[Docket No. 2002–NM–128–AD; Amendment 39–13269; AD 2003–16–16]

**Airworthiness Directives; Boeing Model 747–400 Series Airplanes Equipped With General Electric Model CF6–80C2 Series Engines**

**ACTION:** Final rule.

Electro-Mechanical Brake and CDU Cone Brake Torque Check  
Figure 1

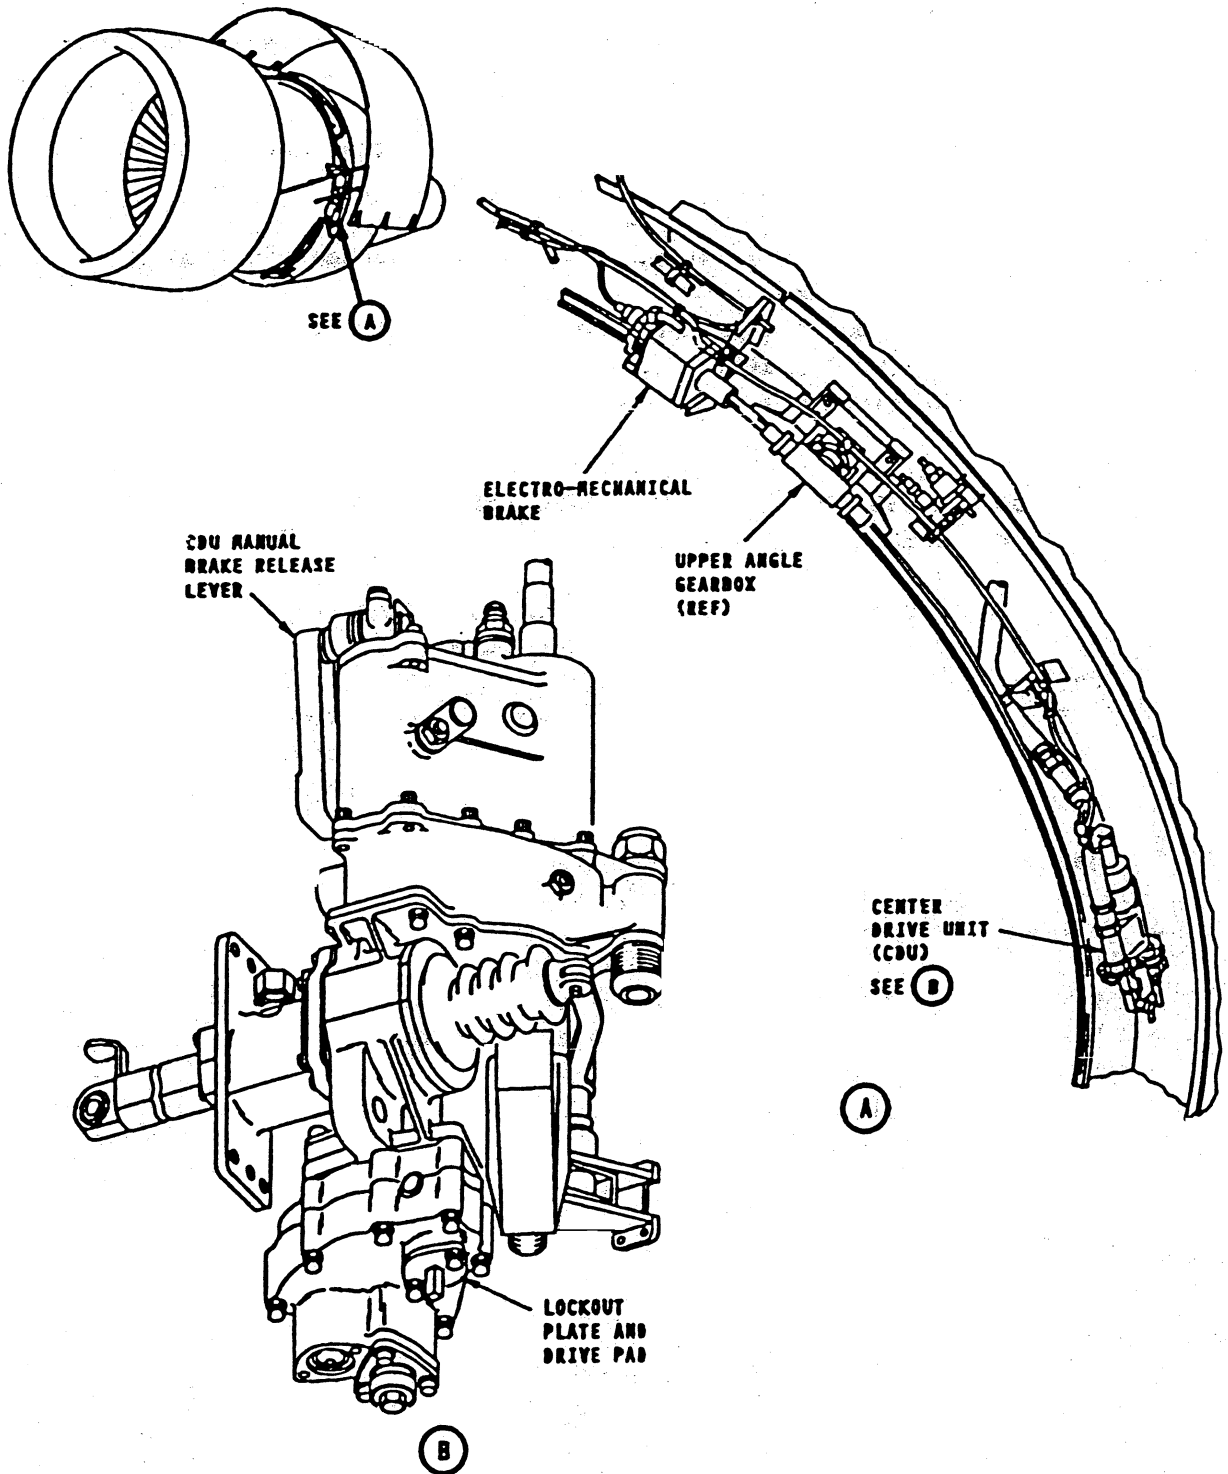
2. CDU cone brake check (Figure 1):

**Caution:** Do not use more than 100 pound-inches of torque when you do this check. Excessive torque will damage the CDU.

(7) Turn the torque wrench to try to manually extend the translating cowl until you get at least 15 pound-inches.

**Note:** The cone brake prevents movement in the extend direction only. If you try to measure the holding torque in the retract direction, you will get a false reading.

(8) If the torque is less than 15 pound-inches, you must replace the CDU.
